ADDENDUM NO. 2

CATTARAUGUS COUNTY
LITTLE VALLEY COUNTY CENTER
ELEVATOR IMPROVEMENTS

SEPTEMBER 23, 2022

Project No. 307670

6 PENTHOUSE MACHINE ROOM PLAN
SCALE: 1/4" = 1'-0"

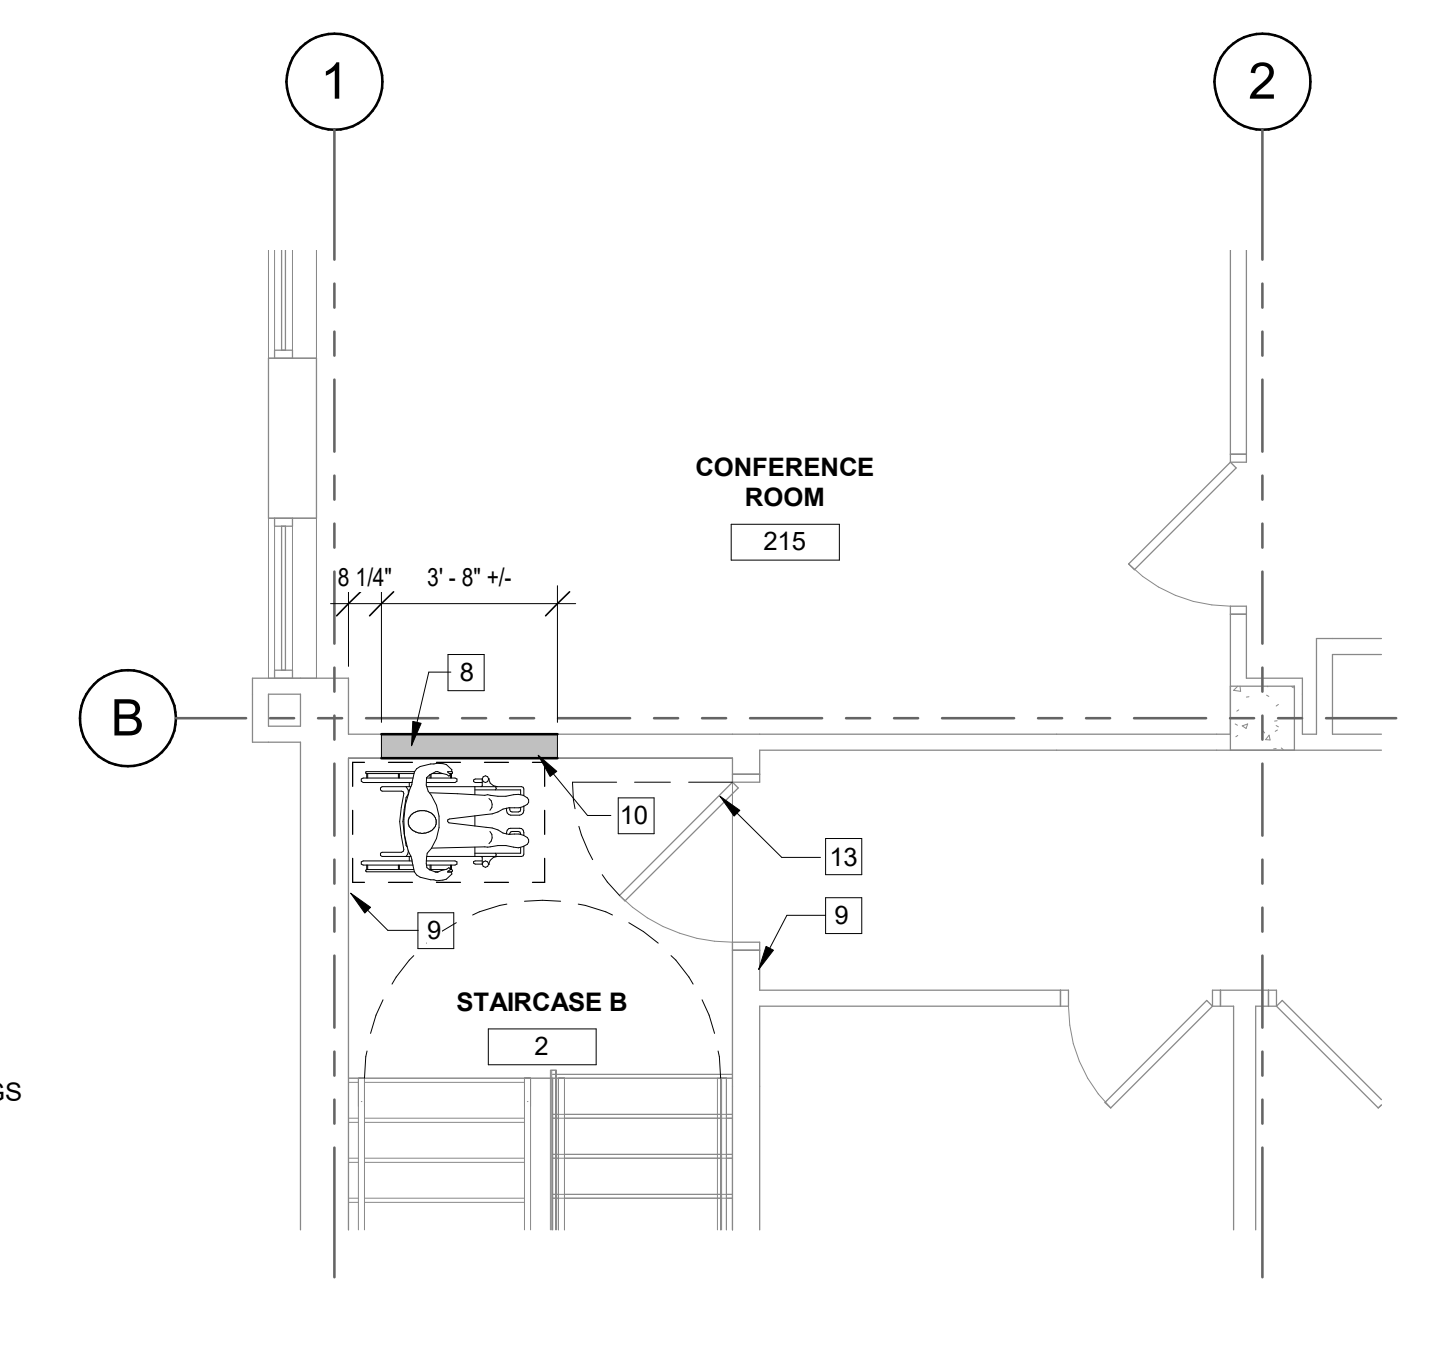
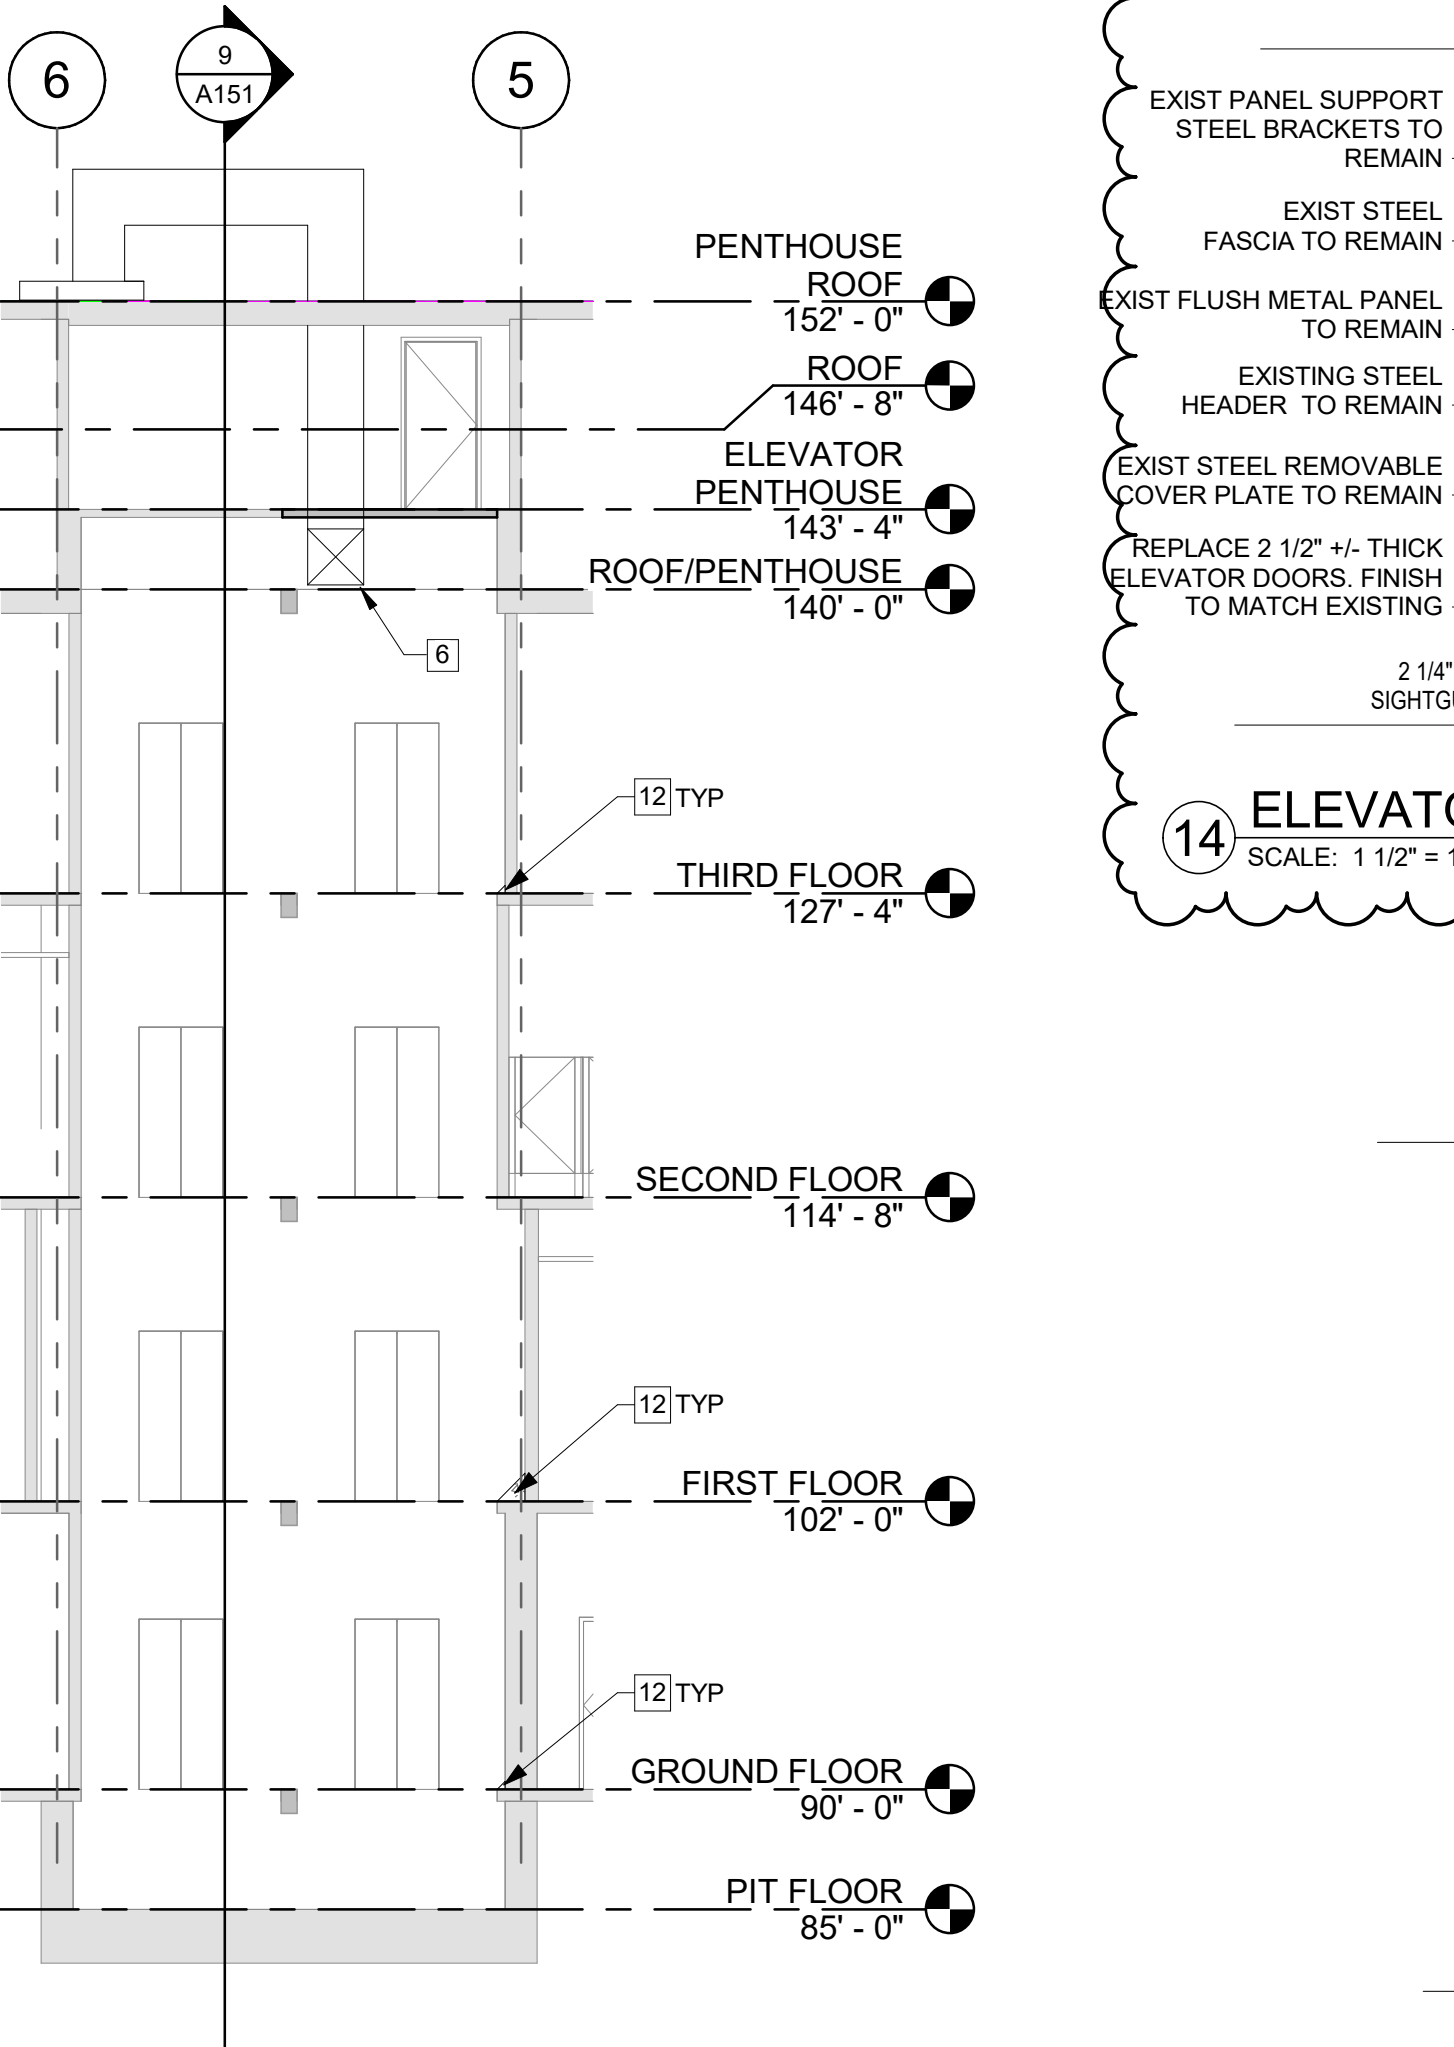
DELETE: Architectural drawing sheet A151.

ADD: Architectural drawing sheet A151 attached as part of this addendum.

- h. All new wiring, traveling cables and hardware
 - i. Inclusion of a \$25,000 per car cab allowance. **(Elevator cab finish selections are to be upgraded to match new elevator PE2 as identified on drawing sheet A151.)**

12 ELEVATOR PIT LADDER
SCALE: 1/2" = 1'-0"

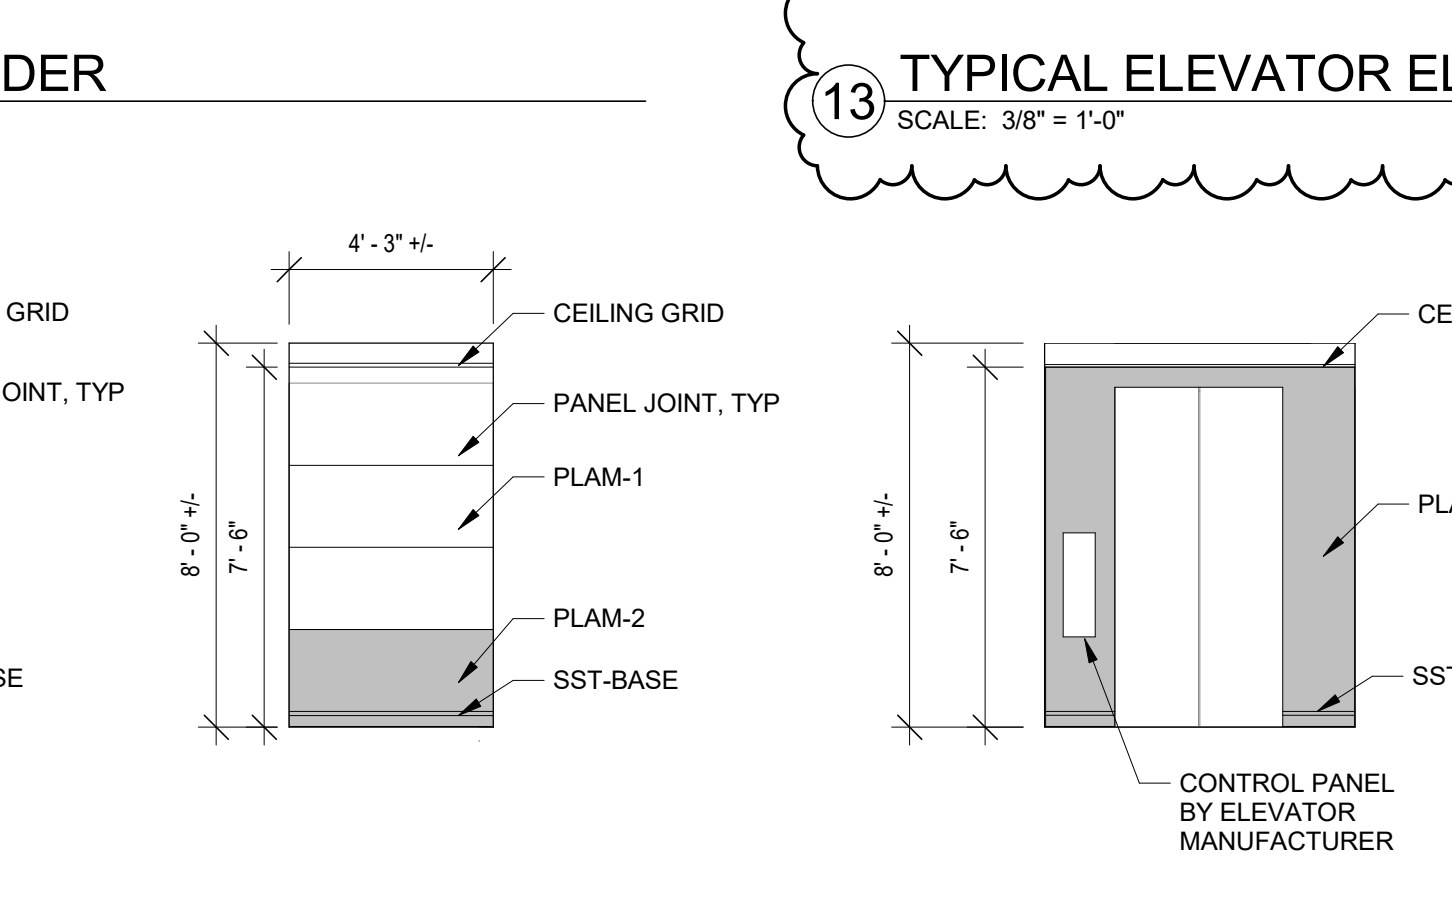
- q. Install new pit permanent fixed metal ladder. (Refer to details on Arch drawing, Refer sheet A151)
 - 1) Ladder shall extend no less than 48” above the sill of the access door. Handgrips shall extend from the ladder to a point no less than 48” above the sill of the access door where the ladder does not comply.
